**Mimico Residents Association Positions & Comments on Item EY23.6  
Mimico-by-the-Lake Secondary Plan to be presented to EYCC on April 9, 2013 at 7pm**

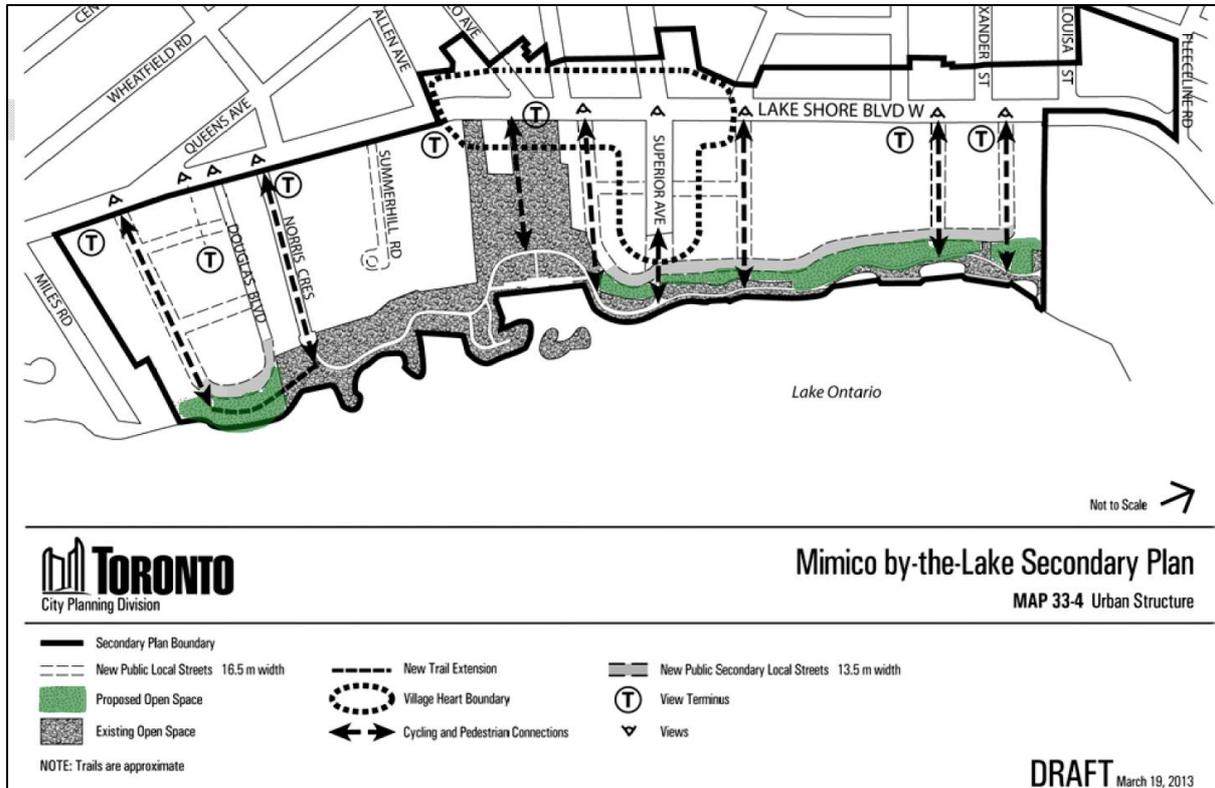
The MRA does not believe the parkland and new public open space provided for in the Plan, particularly adjacent to the lake, is adequate to serve the increase in population resulting from future development.

The Secondary Plan provides the community with only an additional sliver of "New public open space" (see illustration on page 2). The current Linear Park and trail is already proving to be inadequate and overcrowding is an issue - before any increase in area density.

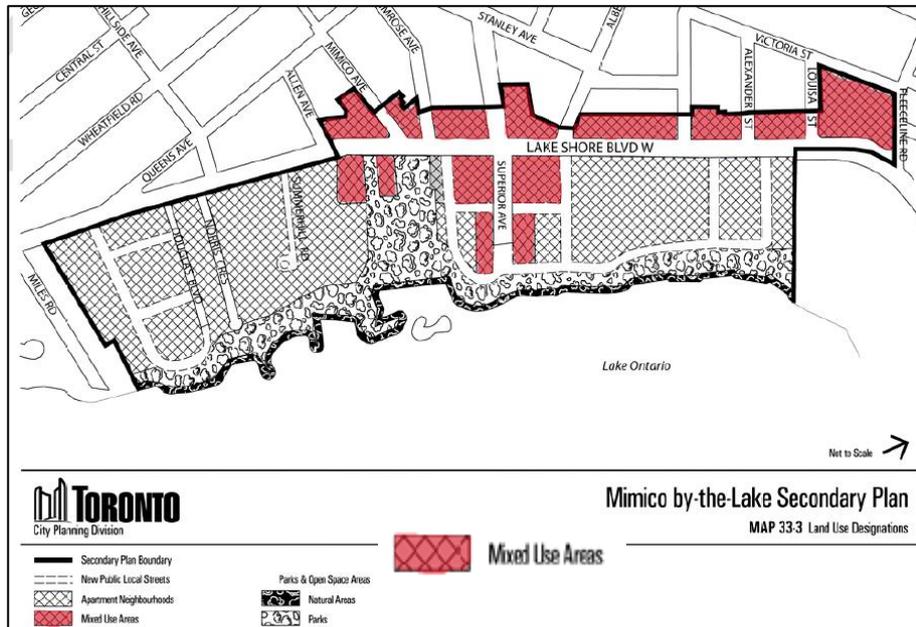
The MRA believes a lake-side mixed-use area would allow the community to share lake-front amenities and spaces like courtyards, shops and restaurants in and around new buildings.

The Secondary Plan proposes no mixed use along the lakefront portion of the development area (see illustration below). Mixed-use is limited to Superior and Lake Shore Blvd. W.
